RESERVED MATTERS APPLICATION FOR SPORTS PITCHES, CHANGING FACILITIES AND ALLOTMENTS, ASSOCIATED INFRASTRUCTURE AND LANDSCAPING PURSUANT TO OUTLINE PLANNING PERMISSION 16/0864 FOR RESIDENTIAL DEVELOPMENT OF UP TO 1100 DWELLINGS AND PROVISION OF PRIMARY SCHOOL, VILLAGE CENTRE, PUBLIC OPEN SPACE, LANDSCAPING AND ASSOCIATED INFRASTRUCTURE WORKS AFFECTING PUBLIC RIGHTS OF WAY 397/3, 397/7, 397/9 AND 397/10, AND DETAILS TO DISCHARGE CONDITIONS 5 (BUILDING MATERIALS), 6 (HARDSCAPING MATERIALS), 7 (BOUNDARY TREATMENTS), 12 (DRAINAGE), 21 (PARKING) AND 24 (LANDSCAPING) – 24/047

Please find enclosed an updated submission to address comments from yourself and the Landscape Officer. The updated submission includes the following:

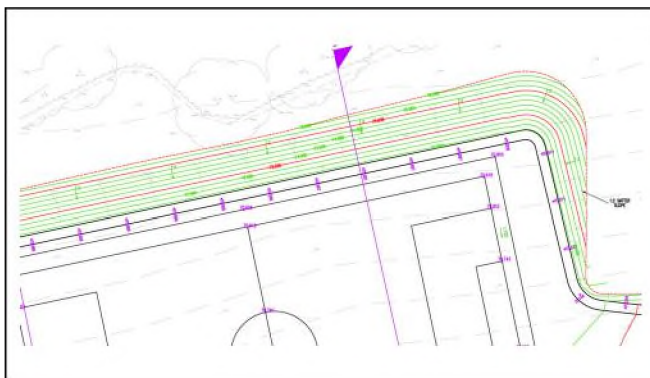
1. No levels are shown on the plan however the engineering plans show most slopes at a steep 1 in 2 batter (refer extract below). – *The banks have been changed to 1 in 3 so they can be maintained but please note that they will be maintained by the Residents Management Company and not the LPA.*

- How will these slopes be maintained as specialist equipment will be required. *Please see above response.*
- How will run-off be prevented onto the immediately adjacent hoggin footpath – a section through the bank, footpath and pitch would be helpful to illustrate the arrangement – *Section are provided with the updated submission.*
